2019-02 – 2013-2018 Dodge Ram 2500/3500 Drag Link Assembly Welds

Created: August 14, 2019

Figure 1: Drag Link Assembly

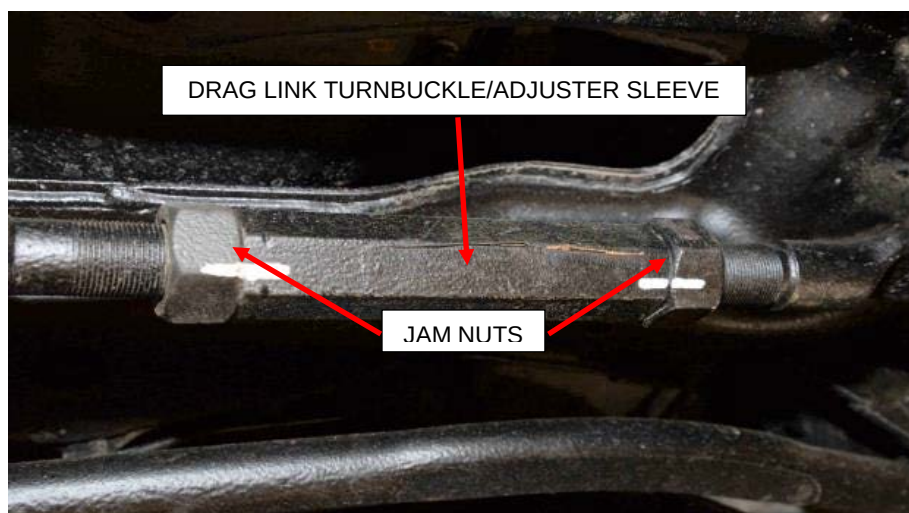
Fiat Chrysler Automobiles US LLC (FCA) initiated a voluntary safety recall of certain 2013-2018 Dodge Ram 2500/3500 pickup and cab chassis vehicles because the outboard steering linkage jam nut(s) could loosen, allowing one end of the drag link to separate from the adjuster sleeve. A drag link separation can result in a loss of directional steering control, which can cause a vehicle crash without warning.

Figure 2: Areas to be Welded

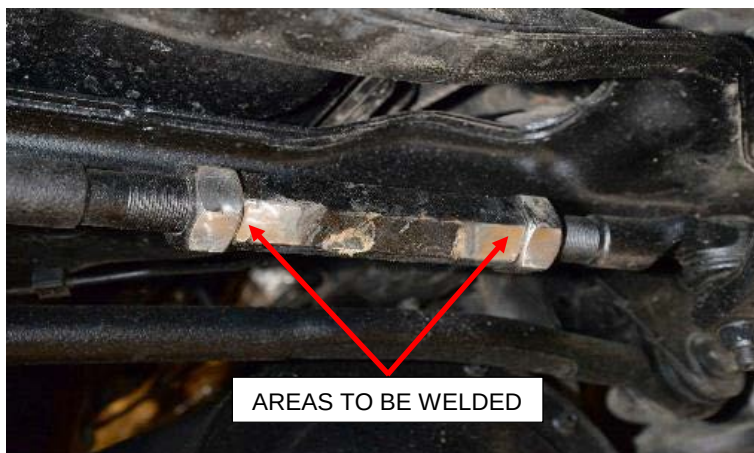
FCA developed a remedy to address the identified defect that involves welding the jam nuts to the adjuster sleeve to ensure that (1) the nuts do not loosen and (2) the drag link does not separate from the adjuster sleeve. Specifically, a weld is applied along the length of one turnbuckle flat on each jam nut.

Based on the above, inspectors are **NOT** to place the affected 2013-2018 Dodge Ram 2500/3500 pickup and cab chassis vehicles out of service if they have the outboard steering linkage jam nuts welded to the adjuster sleeve as shown in Figure 3 on the previous page. This is the manufacturer-developed and approved remedy to the identified safety defect and should not be considered an out-of-service condition under Item 10.c.(2) of the NAS OOSC.
